APPLICATION NO.	FILING DATE	FIRST NAMED INVENTOR	ATTORNEY DOCKET NO.	CONFIRMATION NO.
10/591,188	09/19/2008	Martin Williamson	H27363/9930/98019/0270	7364
92556	7590	02/15/2012	EXAMINER	
HONEYWELL/HUSCH			DINH, BACH T	
Patent Services			ART UNIT	
101 Columbia Road			PAPER NUMBER	
P.O.Box 2245			1724	
Morristown, NJ 07962			NOTIFICATION DATE	
			DELIVERY MODE	
			02/15/2012	
			ELECTRONIC

Office Action Summary	Application No. 10/591,188	Applicant(s) WILLIAMSON ET AL.	
	Examiner BACH DINH	Art Unit 1724

DETAILED ACTION

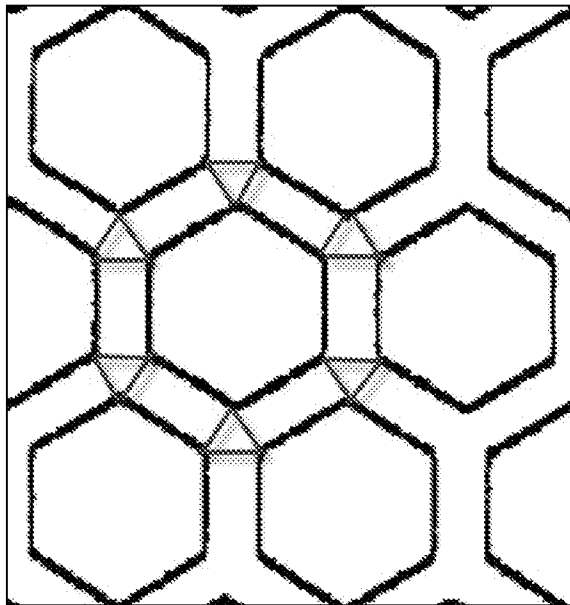
Furthermore, the current collector of Yamada has a thickness of 100 microns or only approximately 0.1mm (5:37-39) and defines a plurality of open areas (figure 5) and the surface area of the portion of the support between the open areas being less than 40% of the combined surface area of the open areas and that portion of the support between them according to the following calculations. The dimension **a** is 0.1 to 5 mm and the dimension **b** is 0.1 to 5 mm, for the calculation, assuming **a** is 4 mm and **b** is 0.1 mm and the area in figure 5 below is used as an example. The area of the hexagon is calculated by equations $((3\sqrt{3})/2)*L^2$ or $(\sqrt{3}/2)*W^2$ (according to

<http://homepage.mac.com/terhorab/iblog/B1032916816/C181698761/E174145342/Media/hexagonArea.pdf>) where L is the side length and W is the width between two parallel sides of the hexagon. The area of the portion between the hexagons are divided into a plurality of equilateral triangles with each side equals to the dimension **b** and rectangles with the width equals to the dimension **b** and the length equals to the side of the hexagon or half of the dimension **a** according to the source above. Thus, the area for each hexagon is 10.39 mm^2 , the area for each rectangle is 0.2 mm^2 and the area for each triangle is 0.0043 mm^2 . The section of figure 5 below has 7.5 hexagons, 20.5 rectangles and 15 triangles; therefore, the total area of the section of figure 5 below is 82.09 mm^2

and the percentage of surface area of the portion between the hexagons and the total area of the section below is 5.073%.
